Re: 2020-12-040, Ballard's Wharf Realty, LLC, Maintenance Dredge Application, AP 6, Lot 159, Block Island, RI 02807

On behalf of applicant: Ballards Wharf Realty, LLC, owner AP 6, Lot 159, verification of bulkhead wall, during & post dredge operations.

CROSS SECTIONS PRE & POST DREDGE AP 6, LOT 159, NEW SHOREHAM, RI FOR: PAUL FILIPPI, JULY 27, 2006 SHEET 2 OF 5 1"=40', BY: WARREN HALL, CIVIL ENGINEER

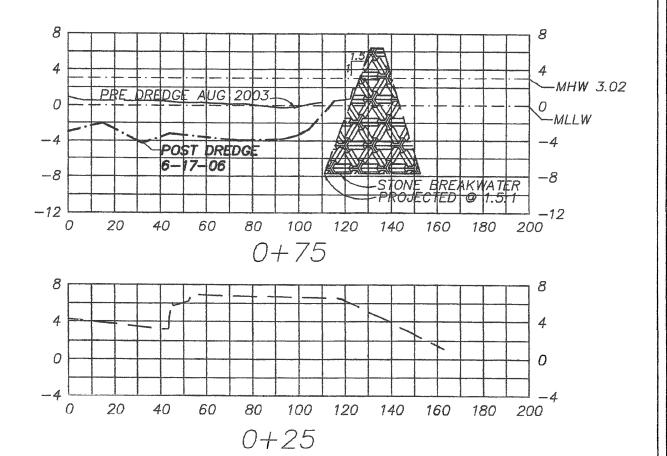
- 1) Post Dredge Topo Survey, sheets 1 & 2 of 5, dated July 27, 2006, as built dredge depth to -3 mllw along bulkhead and -4 mllw 5' off face of bulkhead
- 2) Letter dated 9-3-2003, myself to Ken Kubic (via fax) clarifying proposed -4 dredge depths along bulkhead
- 3) Email from Dan Frates, Borne Consulting Engineering, dated 9-26-2003, with clarification of dredge depth to be -4.0 along bulkhead
- 4) Bourne Consulting Engineering, transmittal letter dated 9-29-2003 with sheets 1 thru 4 showing Bulkhead Improvements with proposed dredge grade of -4 mlw along steel sheeting and a tip elevation of -32

Based on this information, my inspection of the bulkhead condition, in 2000, 2006, 2011, and 2020, I find the steel bulkhead capable to resist all prescribed loadings and a dredge depth of -4 MLLW along the face.

SHEET 3 OF 4 DATE: 9/22/03

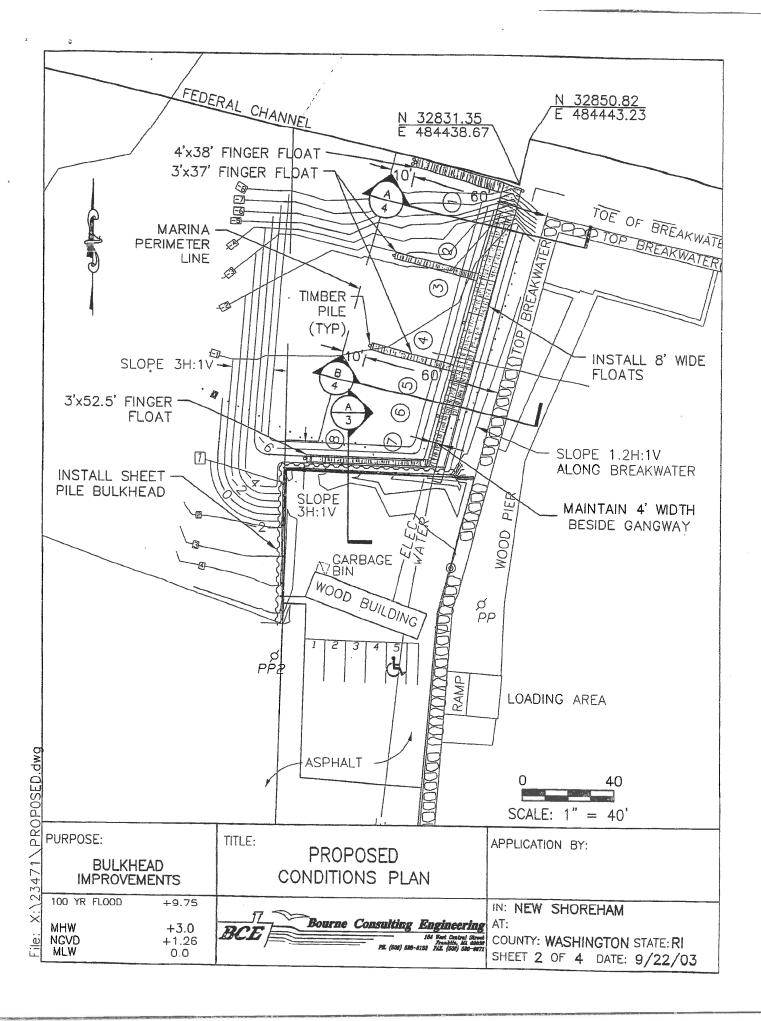
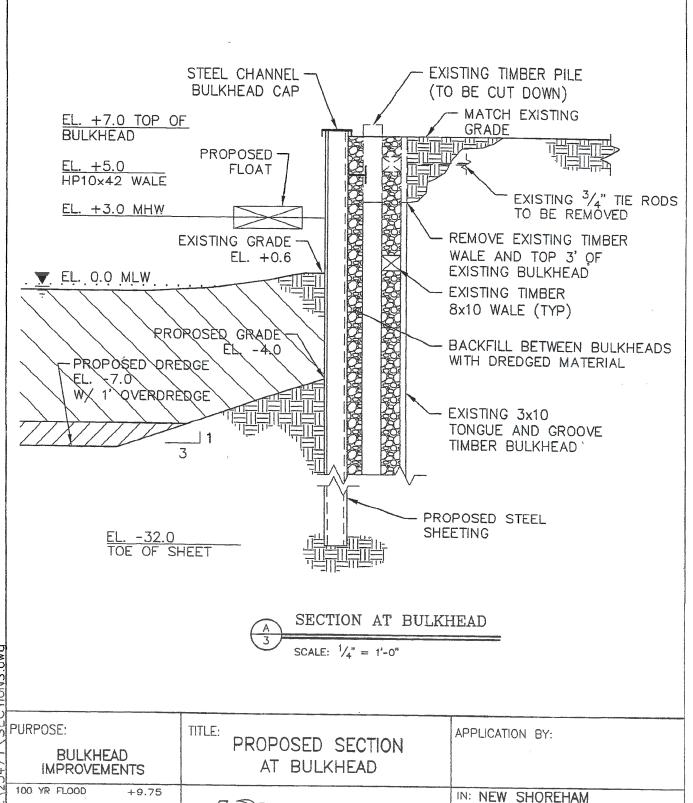
We see two discrepancies between our drawings and the drawing you sent us on September 24.

First, at the northwest corner of the proposed bulkhead, the BCE drawings show the proposed dredge El. -4.0 extending 10' south of the corner along the west face, creating a benched area. This was directed in a facsimile from Ken Kubic on September 17.

Second, the lengths of the finger float are slightly different due to location of them in relation to the breakwater. Per a discussion between Ron Bourne and Ken Kubic on September 19, the western edge of the outshore finger is 60' from the top of the breakwater, excluding the timber piles at that end. The western end of the other finger floats (except for the southernmost along the bulkhead) are 60' from t he top of the breakwater including the timber piles at the end. Please refer to Sheet 4 of 4 by BCE for sections of these finger floats.
